MODEL NAME : *E-Docking (For APR)*

PCB NO : *LA-3954P*

## E-Docking Schematics Document

**REV : 0.4 (DELL: X03)**

<b>Compal Electronics, Inc.</b>		
<b>E-SATA+USB Port x1</b>		
Size	Document Number	Rev
	<b>LA-3954P</b>	<b>X03</b>
Date:	Friday, April 18, 2008	Sheet 10 of 29

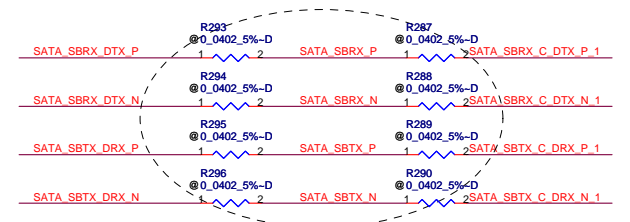
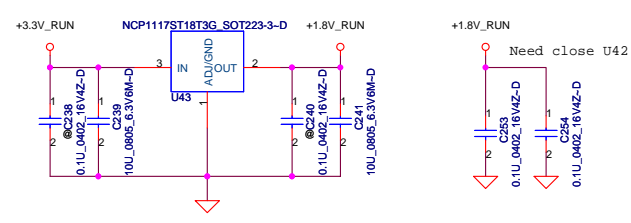
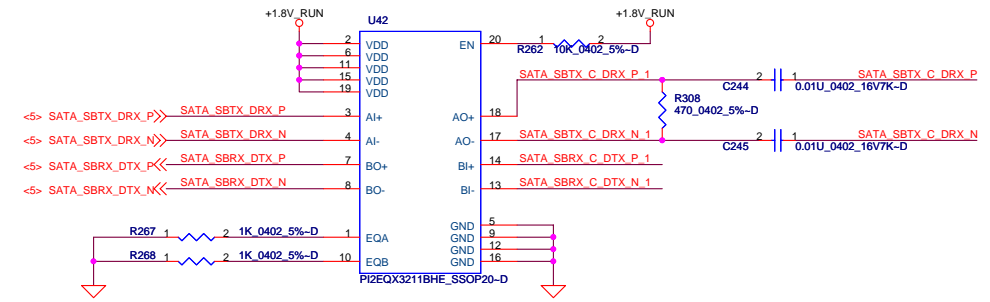
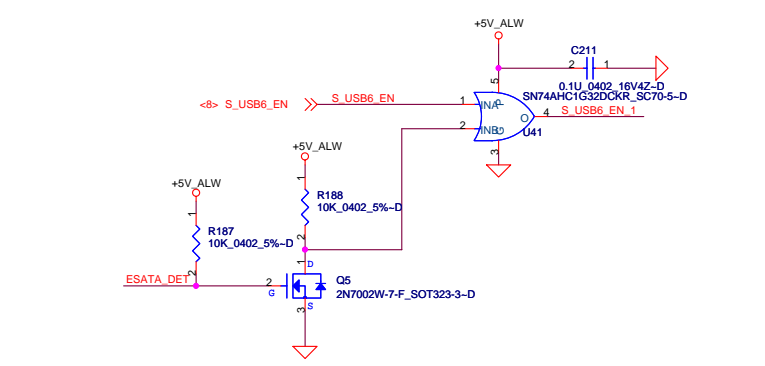
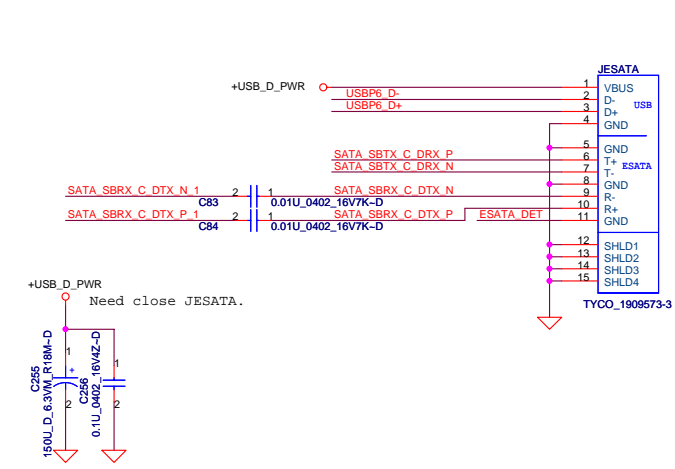
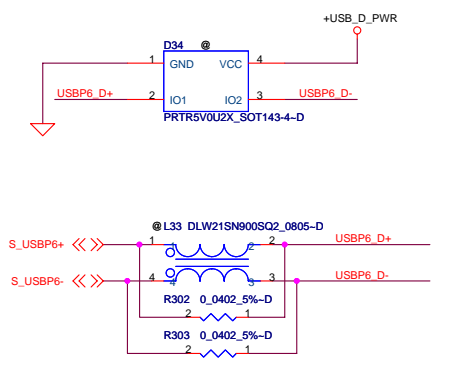
Bill10703: Please place under U42. (co-layout..)  
 Benson0912: If populate R287~290 and R293~R296, the U42,R262, R267, R268 ,U43, C239, C241 is no-stuff and C244,C245 will change to 0ohm.

### Dock PS\_ID Detector

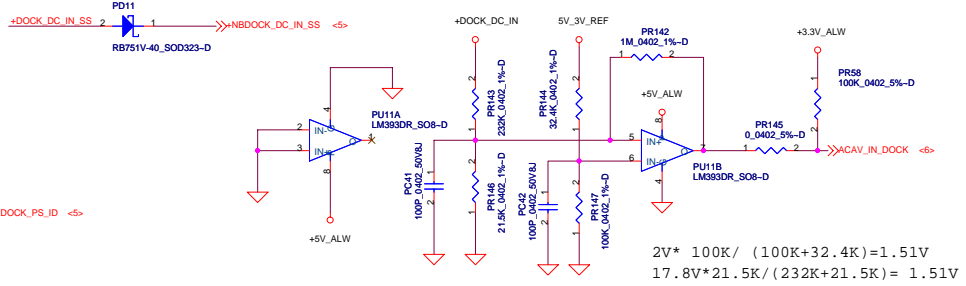
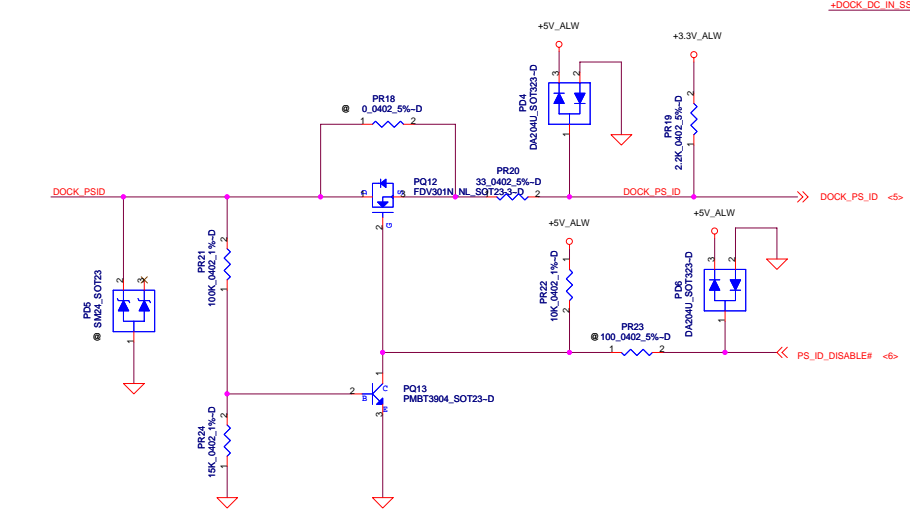
1. Populated PR68
2. Reserve delay circuit, no stuff.
